ADDENDUM

Project: CSOB Emergency Generator

Project No.: 2015-127

Addendum No.: 1

Sheet E1.0 – Building 3 Electrical Plan

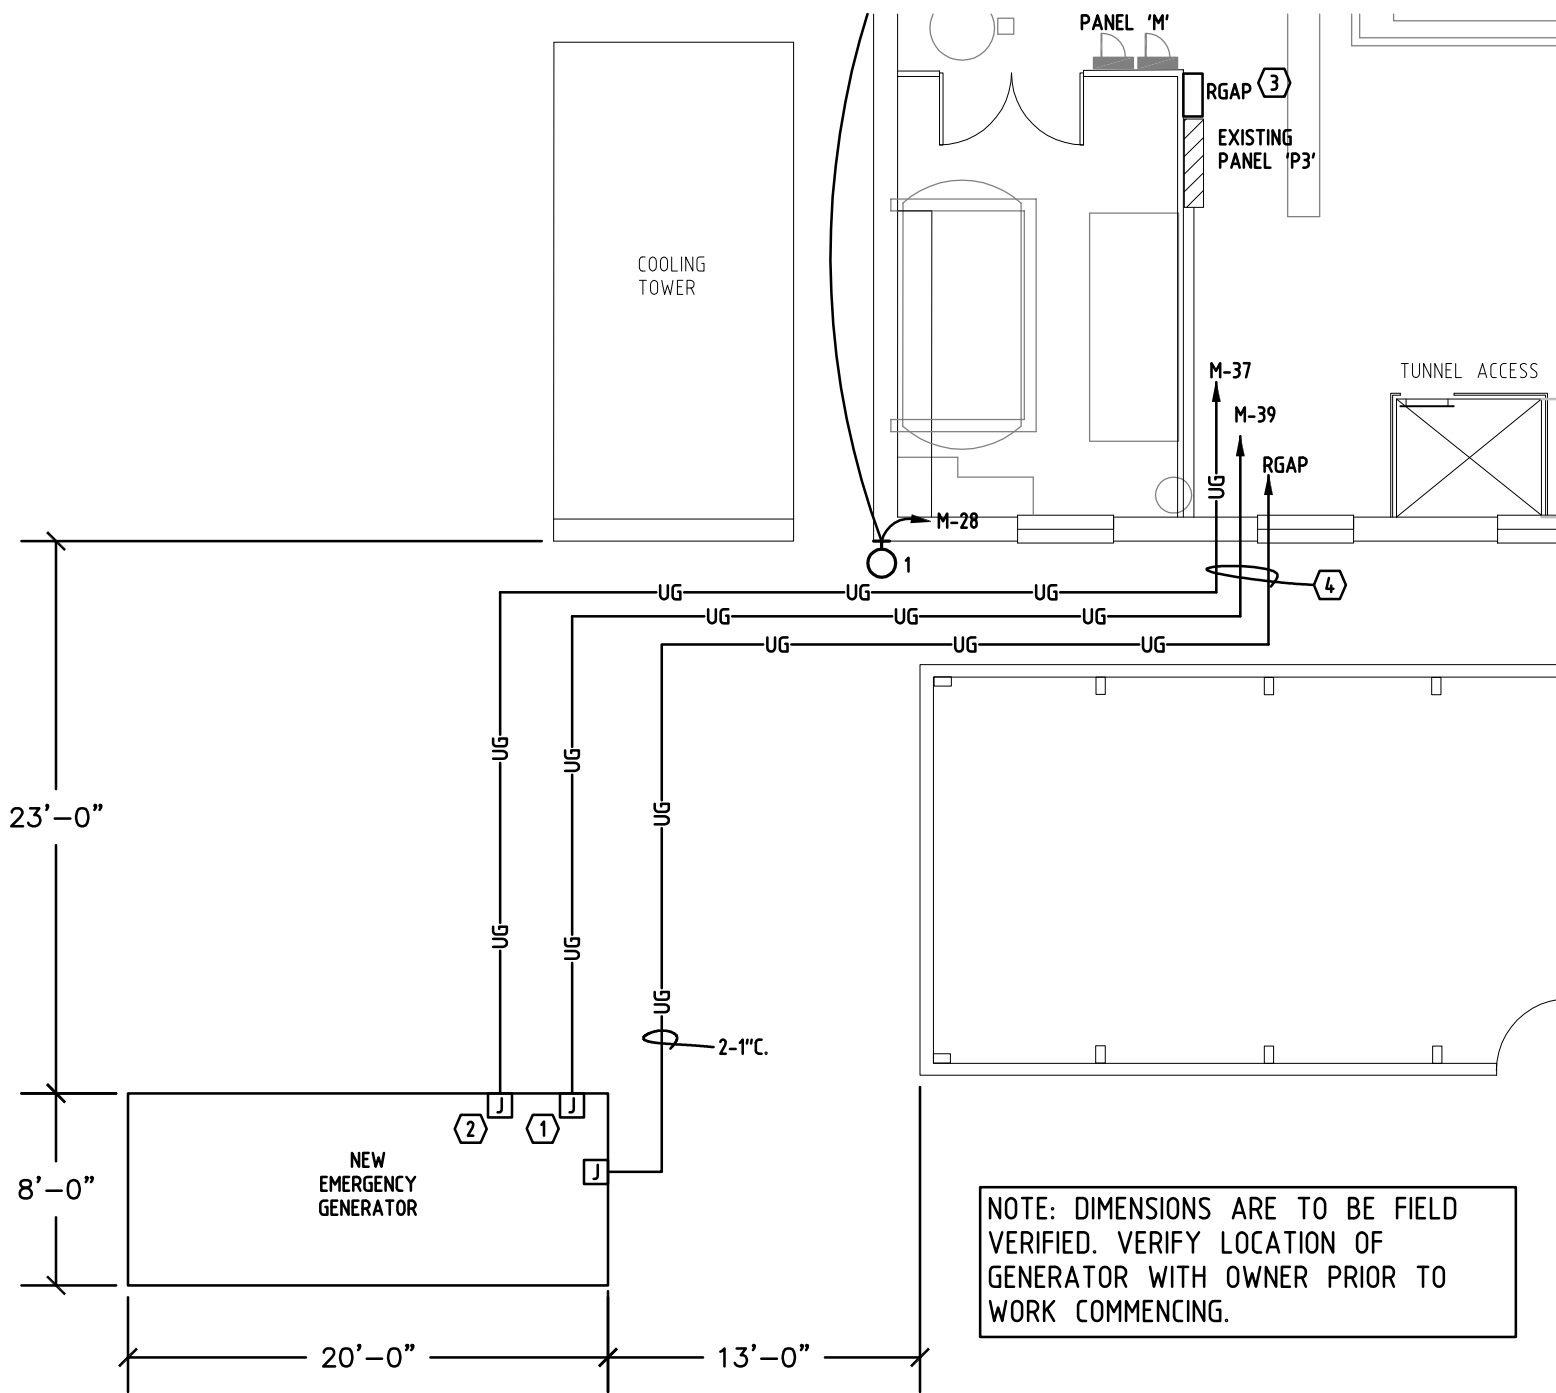
1. The location of the Generator shall be changed to reflect the attached revised drawing – E1.0. The fuel fill opening on the Generator sub-base tank shall face to the south (towards the parking lot).
